# UNITED STATES PATENT AND TRADEMARK OFFICE

APPLICATION NO.	FILING DATE	FIRST NAMED INVENTOR	ATTORNEY DOCKET NO.	CONFIRMATION NO.
10/686,866	10/16/2003	Chung Long Chang	24061. / TSMC2002-1305	7401
42717	7590	09/08/2005	EXAMINER	
HAYNES AND BOONE, LLP 901 MAIN STREET, SUITE 3100 DALLAS, TX 75202			CRANE, SARA W	
			ART UNIT	PAPER NUMBER
			2811

**Office Action Summary**

Figure 1C is copied on the next page:

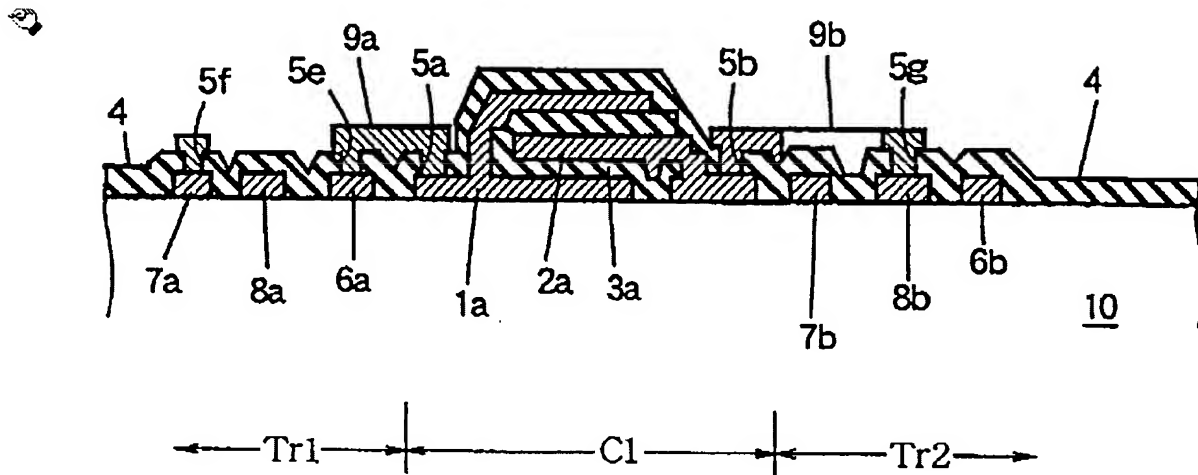
As noted previously, with respect to claim 4, the "first electrode" is identified as at least a part of the horizontal part of 1a. The "first interconnect" is a horizontal part of 9a. These two features are connected by a conductive path consisting of a vertical region extending through the dielectric layer overlying 1a, which is filled with conductor. This vertical region is identified as the "first via," as required by the third line from the end of the claim. A "first insulating layer" 3a is located over the "first electrode." A "second electrode" is a horizontal part of 2a, which is located over the "first insulating layer." A "second interconnect" is a horizontal feature above 5b. (This feature is identified as 9b in figure 1B and above.) The "second electrode" and the "second interconnect" are connected by a conductive path consisting of three parts: 1) a vertical region extending below electrode 2a (contacting electrode 2a at its right side, and contacting an unnumbered horizontal layer below 5b), 2) the horizontal layer itself below 5b, and 3) a

vertical region extending below interconnect 9b (contacting the horizontal layer 2) at its right side, and contacting 9b at its left side). Either of the vertical regions 1) or 3) could be identified as the "second via" of the next to last line of the claim (because either of these regions serve to connect the "second electrode" and the "second interconnect" and because the claim is written in open claim language).

There is a "second insulating layer" immediately above the "second electrode" and a "third electrode" immediately above the "second insulating layer." The "third electrode" is connected to the "first interconnect" 9a by a conductive path consisting of three parts: 1) a vertical region extending above 1a, 2) a horizontal region immediately to the left of 1a, and 3) a vertical region extending above 5a. The vertical region 1) is identified as the "third via" of the claim, because it serves to connect the "third electrode" and the "second interconnect," and because the claim is written in open claim language.

Claim 4 is thus anticipated by the reference, and anticipation is the epitome of obviousness. Alternatively, it would have been obvious that the designations of the claim language, such as "electrode" and "interconnect" describe functions of the Hoshi regions.

With respect to claim 19, a "transistor element" is located at, for example, Tr2, with metallization regions shown on the right side of figure 1C. "Substrate" would be read on the part of the semiconductor layer located at least under the transistor. The "dielectric layer" is read on the top dielectric layer shown in the figure, which is identified by a 4 on the right side of the figure. The "first interconnect" 9a is located above this

dielectric layer, coupled to the "first electrode" by a "first via," and to a "second electrode" by a "second via" as set forth above. The "second interconnect" 9b is also above the dielectric layer, and is coupled to the "second electrode" by a "third via" as described above. A "fourth via" is shown below 5g, at the right side of the figure, which couples 9b to transistor Tr2. Claim 19 is anticipated by the reference, and anticipation is the epitome of obviousness. Alternatively, it would have been obvious to one of ordinary skill that the claim language designations identified above describe the functions of the Hoshi regions.
